SUBJECT: Contract No. DE-AC24-03OH20152
Statement of Work Requirement 055 - Regulator Reports
PRS 11 PUBLIC FACT SHEET, RESPONSES TO PUBLIC COMMENTS, FINAL

PRS 11: Thorium and Polonium – Contaminated Waste Area

**Response to City of Miamisburg Comments on the
Public Fact Sheet for PRS 11
Public Review Draft
January 2004**

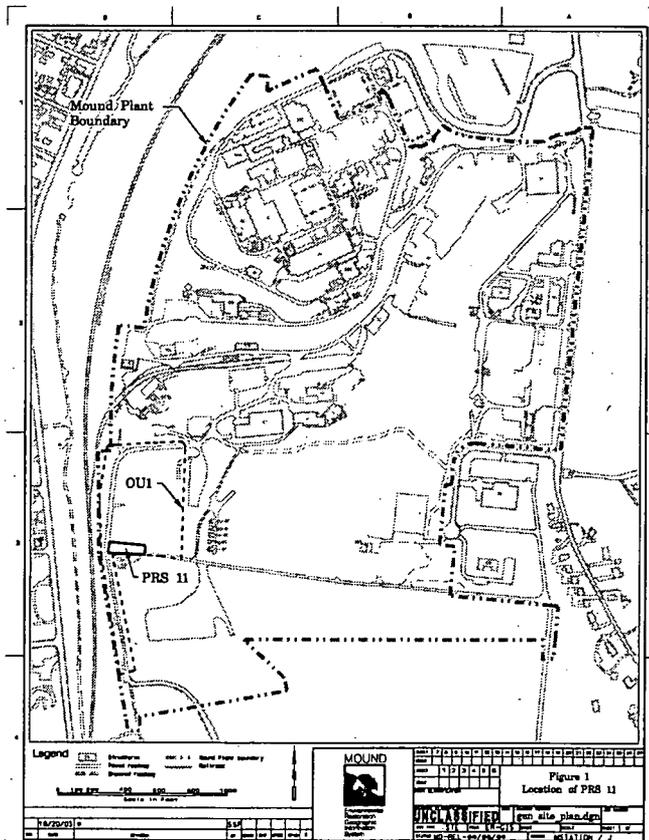
Comment 1. PRS 11 addresses the removal of buried thorium contaminated drums. During installation of drainage features for OU-1, fragments of thorium contaminated drums were actually found. The same magnetic survey that showed the PRS 11 thorium drums also indicated another possible location of buried drums known as "B3". Since there is no evidence to prove that B3 is not thorium contaminated drums, it would seem logical to investigate the B3 magnetic anomaly during the PRS 11 excavation and removal. Will the PRS 11 Removal Action address B3 in any way? If not, how will B3 be characterized and removed if necessary?

The exact location and boundaries of PRS 11 are uncertain. The uncertainties of the boundaries of the contamination of PRS 11 & the associated buried remains of the Dayton Unit Fire should be reflected in both the text and Figure 1 of the Public Fact Sheet.

There is no documentation of the total extent of where the regraded materials were placed, and therefore the exact locations of the boundaries of PRS 11 cannot currently be defined. Regrading is an inherently crude activity. It is reasonable to expect that radioactive contaminants at PRS 11 have a wider dispersal area than is currently defined in PRS 11 Public Fact Sheet text and Figure 1.

PRS 11 Public Fact Sheet Figure 1 shows boundaries for PRS 11 that miss much of the area where the historic remains of the Dayton Unit are indicated to be on Figure 2.7 in the History of Area B (February 1991). Figure 2.7 is attached as Attachment #1.

Response 1. During the Air Sparge and Soil Vapor Extraction systems installation wells AS-N17 and AS-N18 did not indicate the presence of thorium 232 above cleanup objectives. See Figure 1 for a graphical depiction. Recently additional geophysical characterization activities, utilizing the best technologies available, were performed to further define the location of the buried thorium contaminated drums. This latest characterization confirmed the presence of ferrous debris at the B3 location (AS-N18). However, no radioactivity associated with the thorium contaminated drums was detected during the gamma logging of AS-N18. Should the excavation for the buried contaminated drums extend into the B3 anomaly, provisions are in the approved Work Plan for addressing it.

Response 5. During the Air Sparge and Soil Vapor Extraction systems installation wells in the area of the B3 anomaly (AS-N17 and AS-N18) did not indicate the presence of thorium 232 above cleanup objectives. See Figure 1 for a graphical depiction. Additional geophysical characterization was performed in this area during February 2004 in order to more accurately determine the location of the buried contaminated drums. This latest characterization confirmed the presence of ferrous debris at the B3 location (AS-N18). However, no radioactivity associated with the thorium contaminated drums was detected during the gamma logging of AS-N18. Should the excavation for the buried contaminated drums extend into the B3 anomaly, provisions are in the approved Work Plan for addressing it.

Response 1. Geophysical characterization as well as radionuclide assessment via gamma-ray spectroscopy on soils from well installation for the Air Sparge and Soil Vapor Extraction systems has provided more information regarding the thorium drum disposal area. A refined picture can be found in attached Figure 1 and the sample results are contained in Mound Environmental Information Management System (MEIMS) database. Also, recent additional geophysical characterization activities, utilizing the best technologies available, were performed to further define the location of the buried thorium contaminated drums.

Response 2. See attached Figure. Sampling to gather information, with respect to the Dayton Unit debris, will be performed as stated in the PRS 11 Public Fact Sheet. The sampling will occur in the area where the disposal area for the crushed drums overlaps the western end of the old burial trench as well as along the historical burial trench location. This sampling is contained in the Survey Unit Design (Appendix G of the Work Plan).
